**Addendum No. 1**

Re: 1432-1438 Rosemont oh5-12b  
261 Hoch Street oh5-18d

Prepared by:  
The Oregon Group Architects

Project Name: DMHA Rosemont Hoch Electrical Upgrades and A/C Replacement

sheet  
11

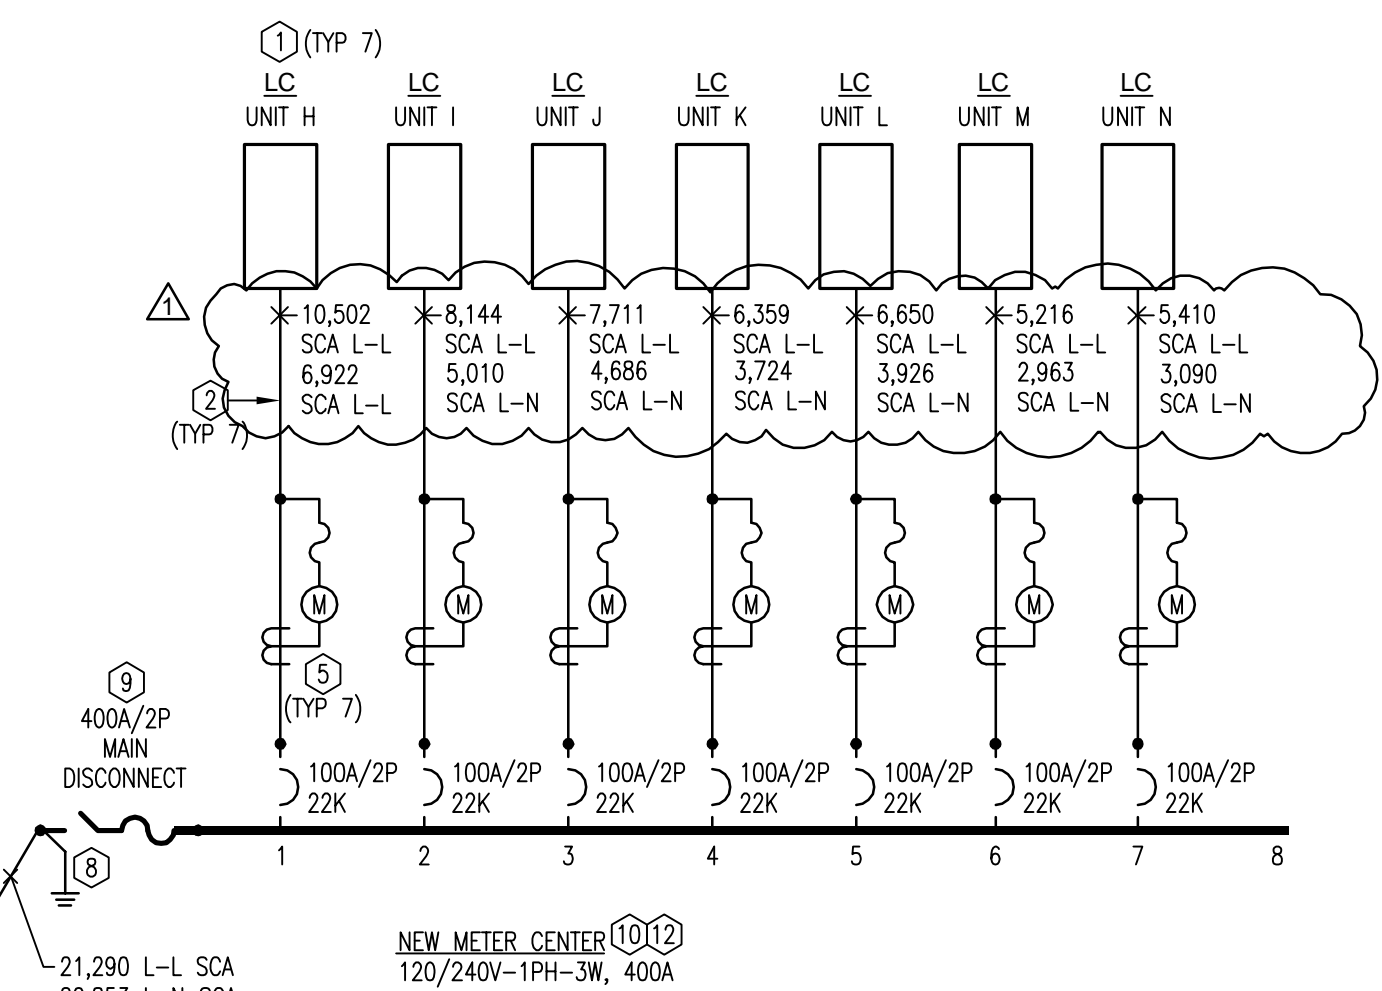
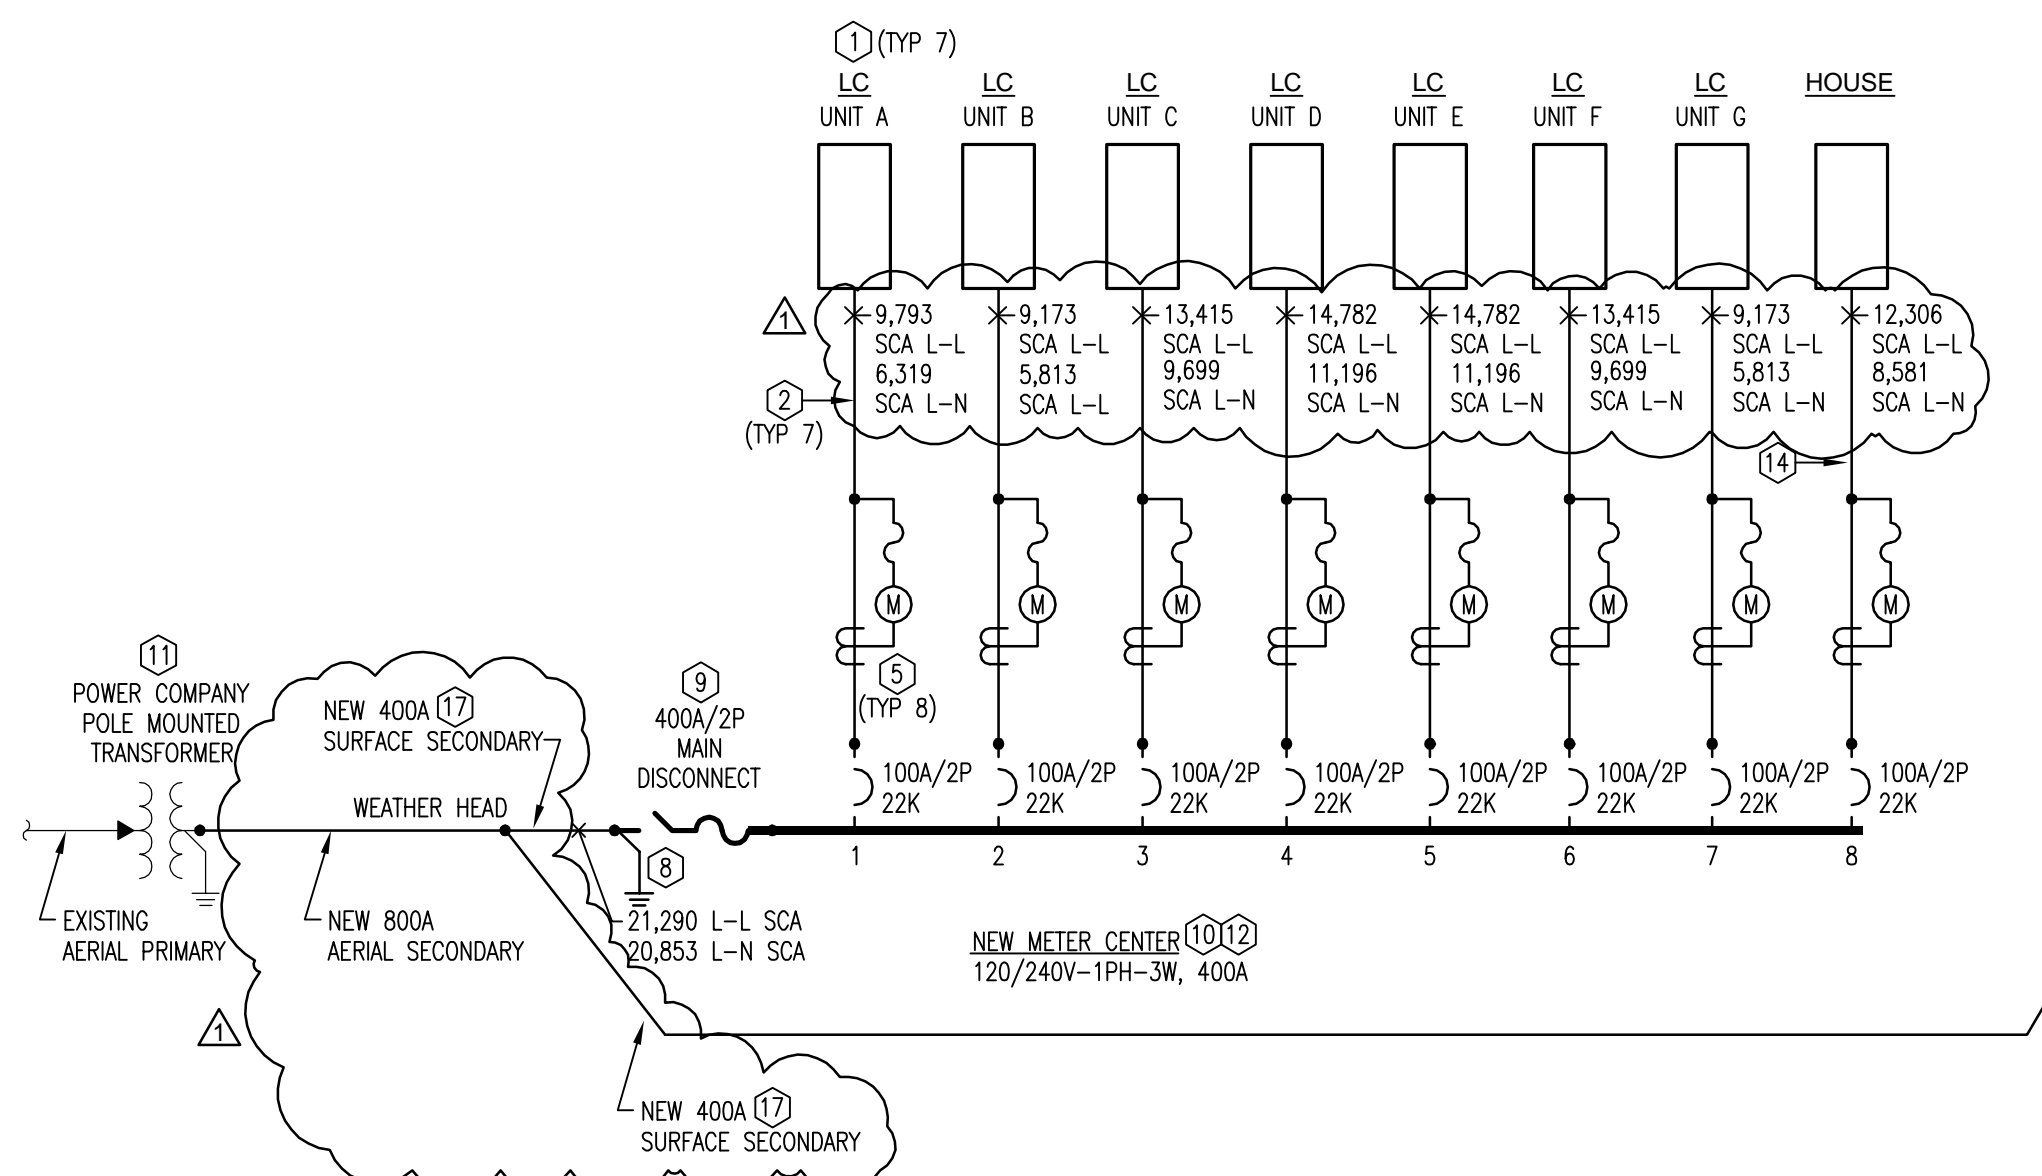
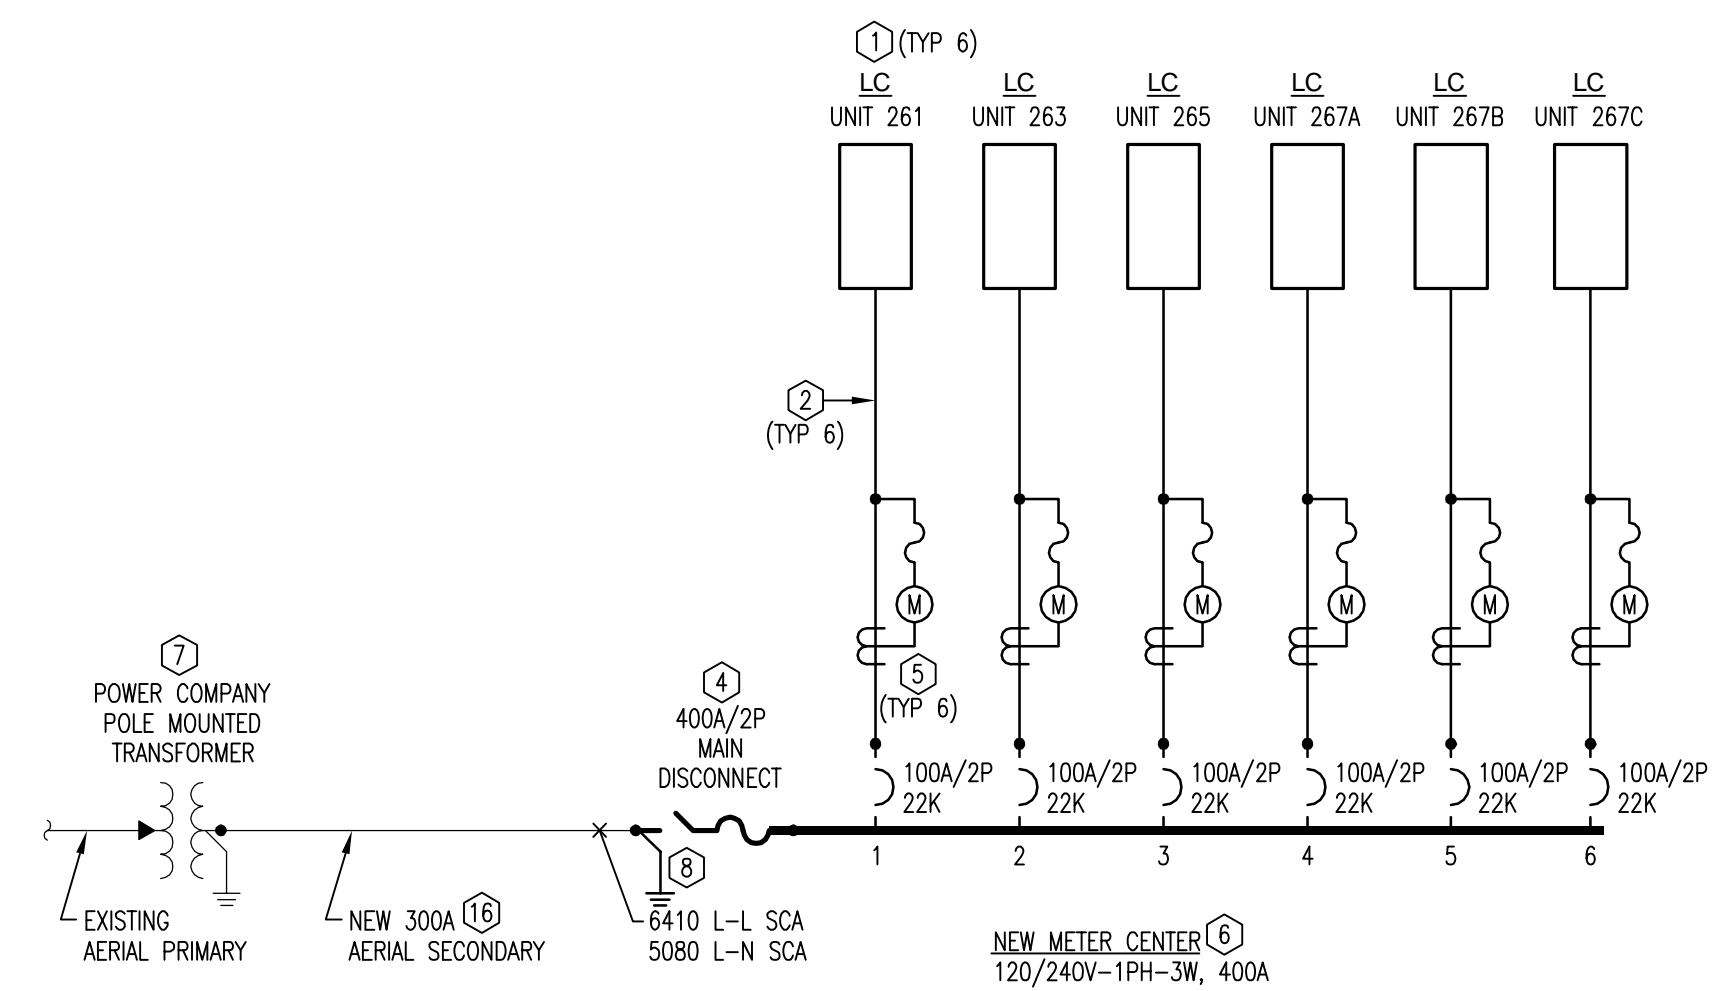
- Item No. 1: Delete Drawing Sheets E1, E3, E4 in their entirety.
- Substitute: Attached revised Drawing Sheets E1, E2, E4 in their entirety. Aerial service conductors to 1432 and 1438 Rosemont shall each extend to one location on buildings. Two meter centers for each Rosemont building are to be located adjacent to each other as shown on plans. Refer to clouded changes on revised sheets. Contractor shall coordinate with DP&L prior to any rough-in, for service drop location and shall provide necessary support structure or weatherhead(s) as required. Existing service conductor wall support brackets shall be removed, and brick surface repaired.
- Item No. 2: Add attached Pre-Bid Attendance Sheet and Meeting Minutes.

- DEMAND LOAD CALCULATION IS BASED ON NEC 220.82.
- FUSE AT 300A LPN-RK.
- 100A METER SOCKET. COORDINATE WITH POWER COMPANY FOR INSTALLATION OF METER.
- DEMAND LOAD ON METER CENTER IS 37.7 KVA, 157 A PER NEC TABLE 220.84, 44% DEMAND FACTOR FOR MULTI-FAMILY DWELLING UNITS.

- FUSE AT 400A LPN-RK.
- DEMAND LOAD ON METER CENTER IS 70 KVA, 291 A PER NEC TABLE 220.84, 44% DEMAND FACTOR FOR MULTI-FAMILY DWELLING UNITS.
- SHORT CIRCUIT CALCULATIONS ARE BASED ON 167 KVA POLE MOUNTED TRANSFORMER, 2.4% IMPEDANCE, INFINITE PRIMARY. 22K FEEDER BREAKERS ARE INDICATED IN METER CENTER.

- PROVIDE WEATHERPROOF MAST, AND EXTEND 3-#350 KCMIL CU SER CABLE TO METER CENTER.
- PROVIDE WEATHERPROOF MAST, AND EXTEND 3-#500 KCMIL CU SER CABLE TO EACH METER CENTER MAIN DISCONNECT.
